Access Compliance Report

Public Rights-of-Way

Intersection ID: 30214	Main Street: HIDDEN_CREEK_DR	Cross Street: MOSS_STREAM_LN	Location: S
ADA ID: 5FC4A7AA2E92	Ramp Type: PerpDiag	Initial Pass/Fail: Pass	Overall Compliance: No
			Severity Score: 22.75

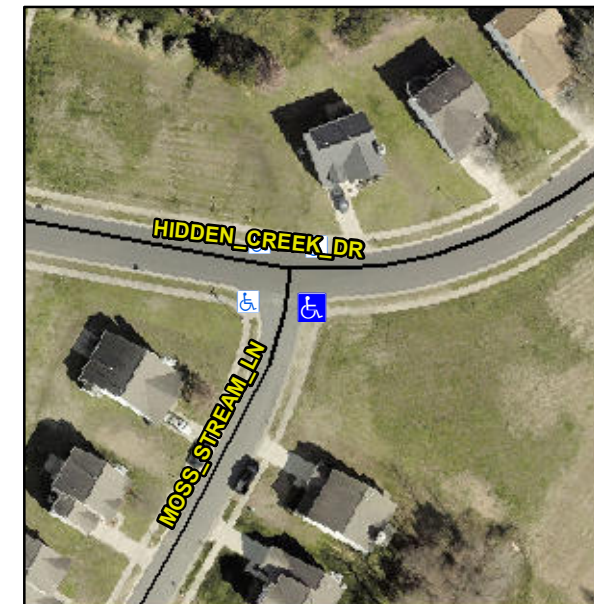
Not Found, R304.5.3, R304.2.1, R305, R302.7.2, R304.5.4

Compliance	Description	Data	Compliance	Description	Data
N/A	Ramp Length (in)	48.0	Yes	Ramp Slope (%)	6.2
Yes	Ramp Width (in)	53.0	No	Ramp XSlope (%)	4.5
N/A	Flare Type LT	Sloped	N/A	Flare Type RT	N/A
N/A	Flare Slope LT (%)	6.2	N/A	Flare Slope RT (%)	1.2
N/A	Flare Traversable LT?	No	N/A	Flare Traversable RT?	No
No	Landing Length (in)	46.5	No	DWS Provided?	No
Yes	Landing Width (in)	104.0	N/A	DWS Contrast?	No
Yes	Landing Slope (%)	1.4	N/A	DWS Length (in)	N/A
No	Landing X Slope (%)	6.4	N/A	DWS Full Width?	No
N/A	Landing Curb? (Y/N)	No	N/A	DWS Offset (in)	N/A
N/A	Shared Landing?	No			
Yes	Gutter Ponding?	No	No	Gutter Slope (%)	6.1
No	Gutter Lip Ht (in)	0.5	No	Gutter X Slope (%)	3.4
N/A	Painted X Walk1?	No	N/A	Painted X Walk2?	No
	X Walk 1 Direction	To N		X Walk 2 Direction	To W
N/A	X Walk 1 Width (in)	N/A	N/A	X Walk 2 Width (in)	N/A
	X Walk 1 Slope (%)	5.6		X Walk 2 Slope (%)	3.0
	X Walk 1 X Slope (%)	1.6		X Walk 2 X Slope (%)	1.6

Remove & Replace Curb Ramp With Two New Directional Ramps or Equivalent. Remove & Replace Gutter.
